**URGENT - FIELD SAFETY CORRECTIVE NOTICE**

**GETINGE ED-FLOW, Automated Endoscope Reprocessor (AER)  
Field Action CAPA 657027**

Date:	25-Oct-2022
Product Issue:	ED-FLOW Dosing issue, CAPA 657027
Affected Product:	Getinge ED-FLOW AER and ED-FLOW SD AER
UDI DI	No UDI – Product not sold in USA and is not an MDR product
SRN	N/A
Resolution:	<i>Getinge propose to rework the devices and remove mechanical interferences causing inconvenience and to make sure that all devices present in the market are working effectively and safely.</i>
Affected Serial Nos.:	All ED-FLOW AER-models manufactured since start 2010 until 2022-08-24.
Field Correction Notice:	<b><i>GD11651 Instruction for Field Action ED-Flow</i></b>
Pages:	6

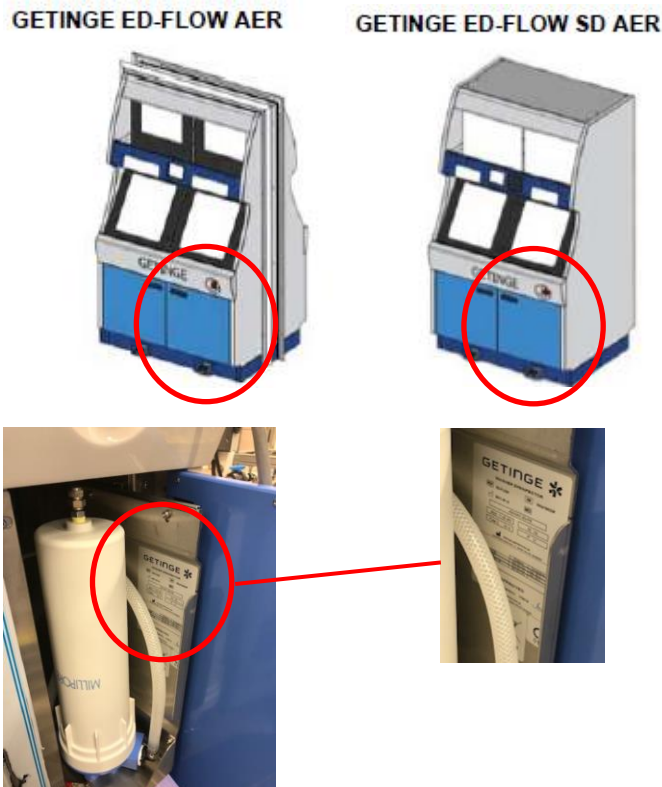
**1. The placement of the colored indicator caps on weighing scale**

The indicator caps on the weighing scale mark the place for the disinfectant container, red for Aperlan A and blue for Aperlan B. The distance between the indicator caps and the inside of cabinet door of the device is very small. During disinfection process, vibrations from the cabinet doors can interfere with the indicator caps on the weighing scale causing it to show potentially incorrect value of dosed detergent.

**2. Routing of the dosing pump hose**

The hose between the disinfectant container and the dosing pump is routed in such way that during dosing, interference is created, possibly causing the scale to show incorrect value of dosed detergent during a disinfection process.

Getinge has released a Field action upgrade hardware kit to correct the issue of incorrect dosing value.

We see the issue as a long-term hazard and want to prevent any related event from reoccurring with our customer. This action is to reposition the indicator caps and change the routing of the dosing hose.
